ISSUE RESOLUTION STATUS REPORT

**KEY TECHNICAL ISSUE:
STRUCTURAL DEFORMATION AND SEISMICITY**

**Division of Waste Management
Office of Nuclear Material Safety and Safeguards
U. S. Nuclear Regulatory Commission**

SEPTEMBER 1998

Figure 11 – Cross section 4. The DWF fault is continuous through model stratigraphy in cross section 4, and is discontinuous in cross section 5 (Figure 12). See Figure 7 for location.

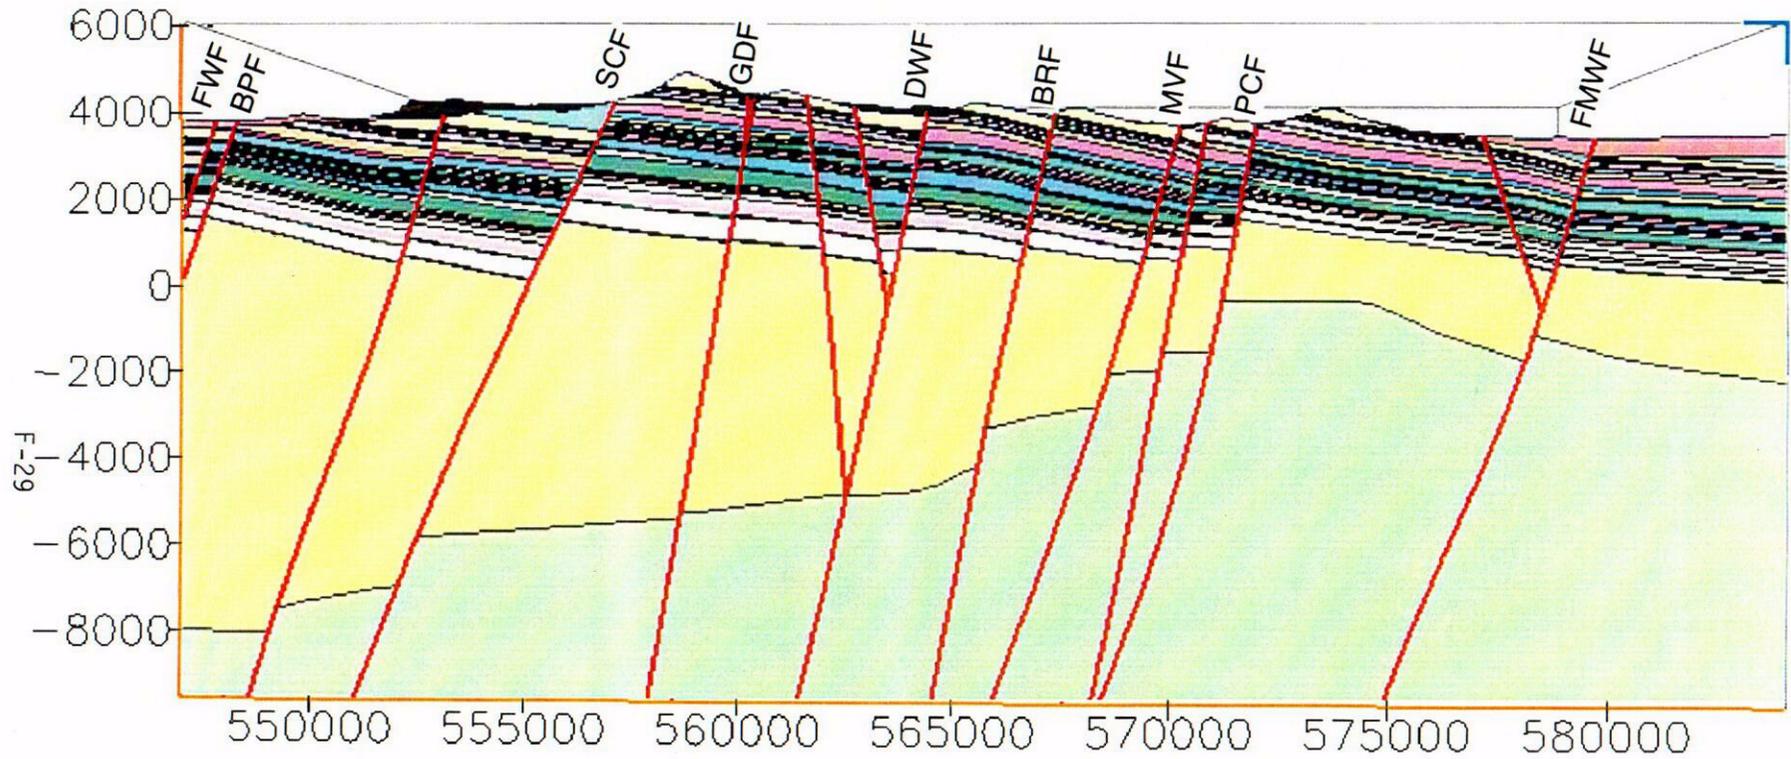
- f. The Dune Wash fault is shown to be truncated against the Ghost Dance fault in Section 5 (Figure 12) but not in Section 4 (Figure 11). This observation suggests a change in dip or "flexing" of the Dune Wash fault so some clarification may be useful.

Figure 12 – Cross section 5 illustrating truncation at depth of DWF fault by GDF fault and reverse of slip sense with depth of BPF fault (see also Figure 13). Section 4 (Figure 11) shows DWF fault continuous through model stratigraphy. See Figure 7 for location.

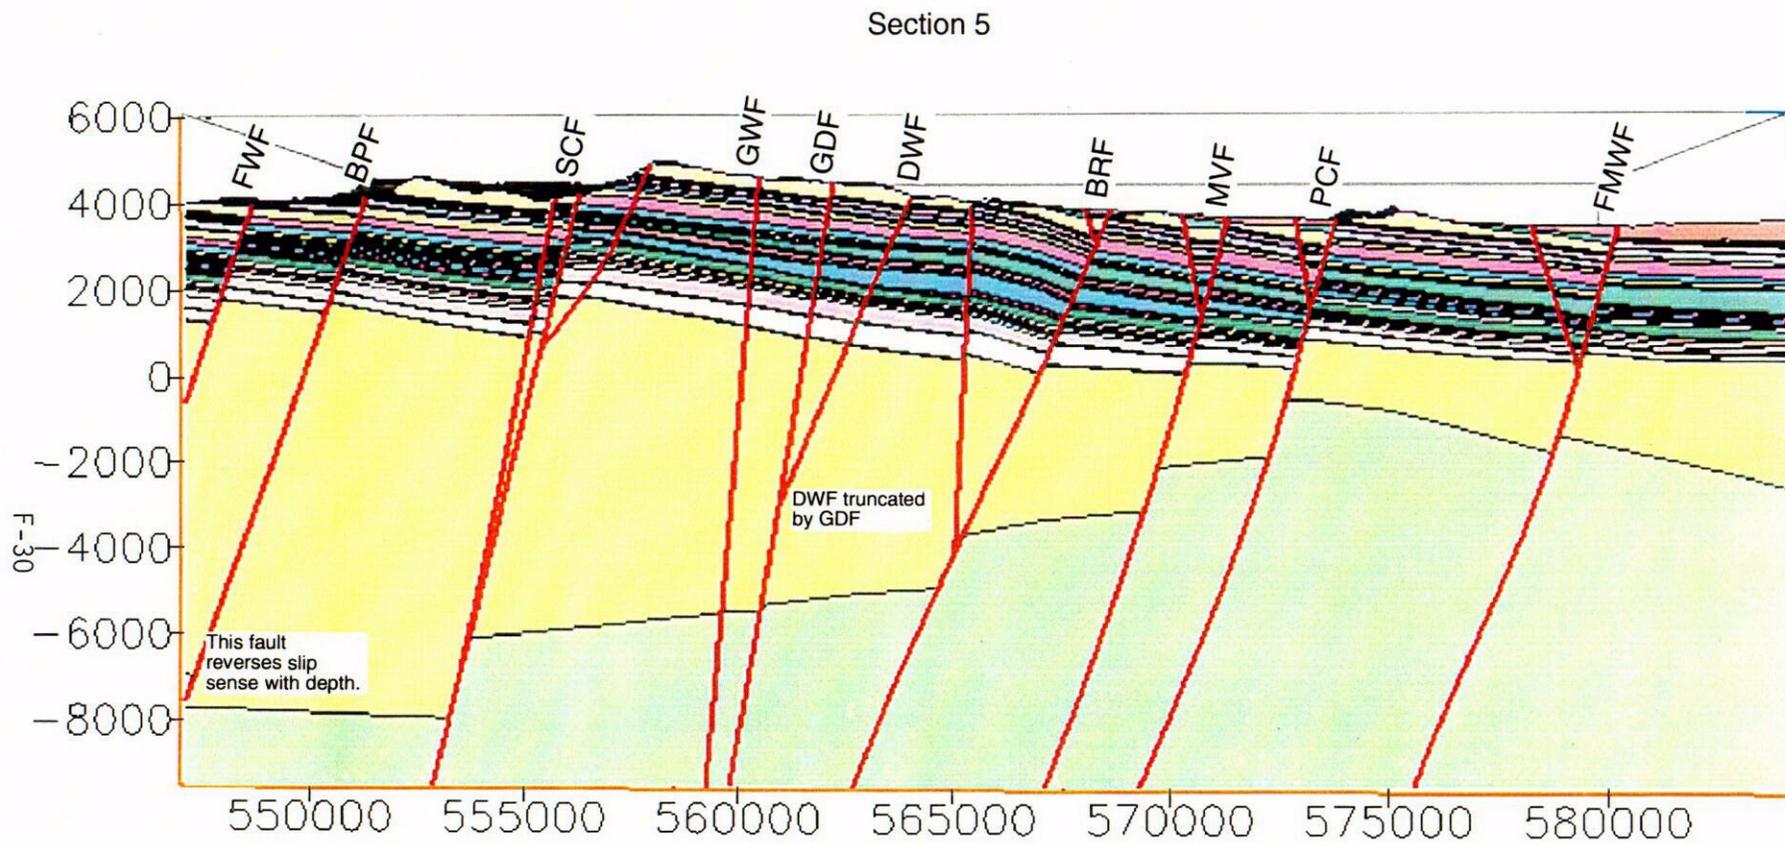
- e. The Boomerang Point fault is shown as reversing displacement at depth in Sections 5 (Figure 12) and 6 (Figure 13). This may be due to model construction artifacts or potential uncertainty on the depth to the Paleozoic surface, so clarification may be helpful.

Figure 15 – Cross section 8 illustrating folded beds in the hanging wall of FMWF without curvature of associated fault surface. See Figure 7 for location.

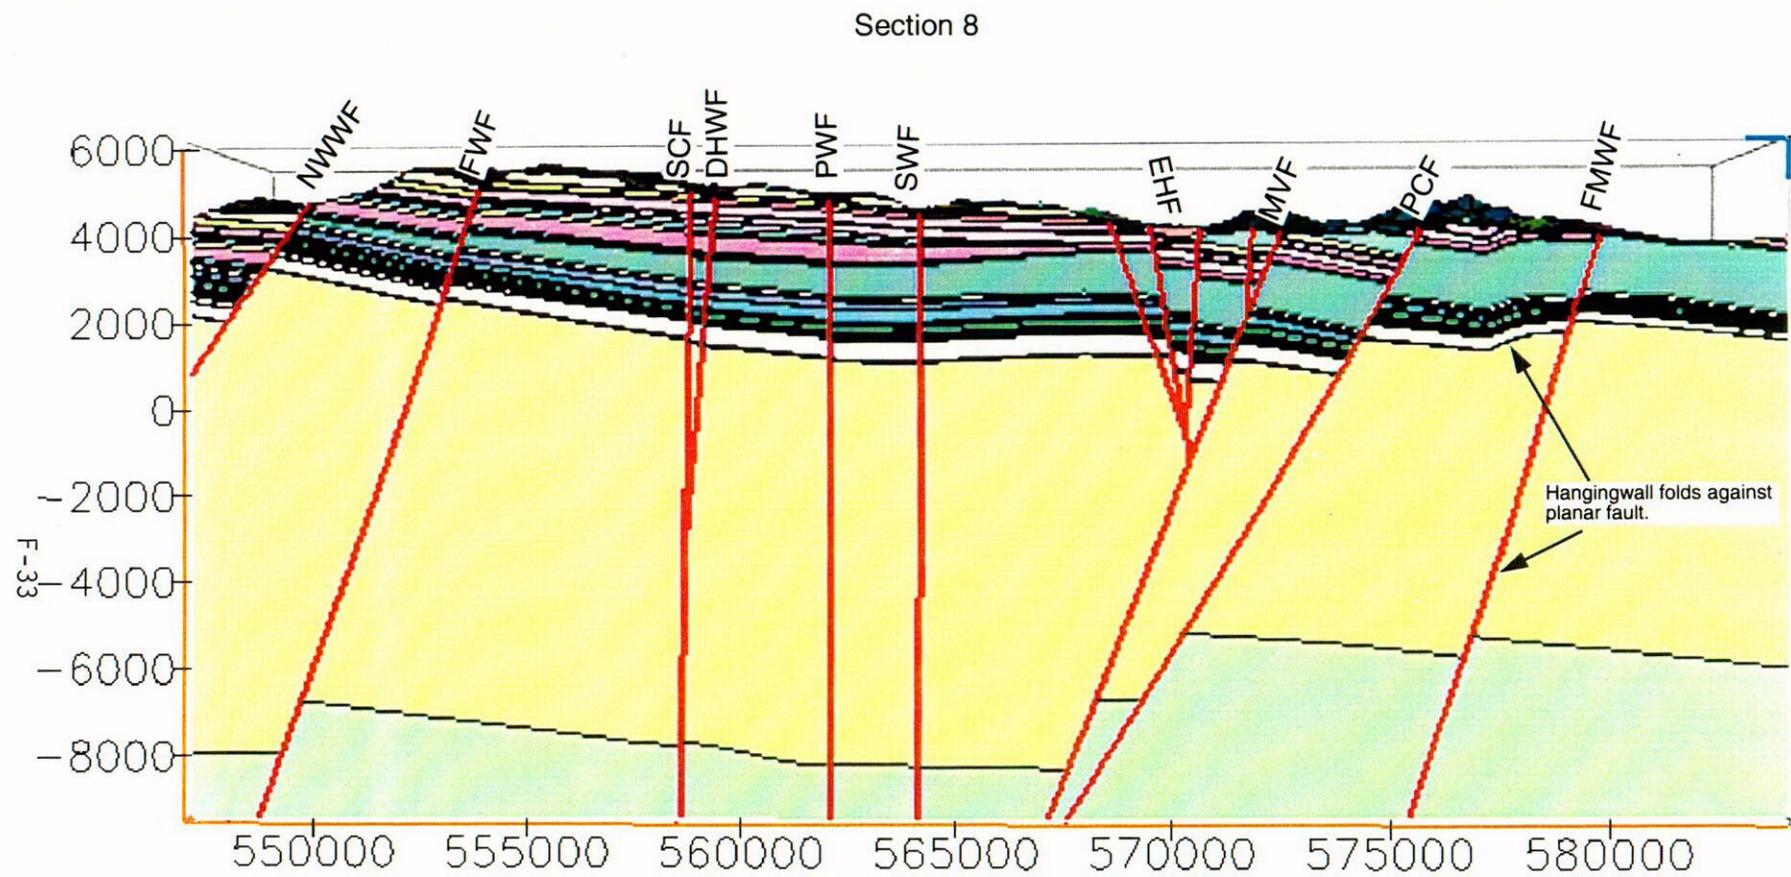
- d. Folding developed in the hangingwall blocks of faults is generally attributed to a curved (i.e., listric) fault geometry at depth (Suppe, 1983; Dula, 1992). Sections 1 (Figure 8) and 8 (Figure 15) through the model appear to illustrate folding of units in hangingwall blocks although GFM3.0 is constructed with essentially planar faults. Explanation of why these units appear to be folded may be helpful. By some interpretations (e.g., Young, et al., 1992), at the depth to which the model was constructed (i.e., 8,000 feet below sea level), the Forty Mile Wash, Paintbrush Canyon, Midway Valley, and Bow Ridge faults would show curved trajectories.
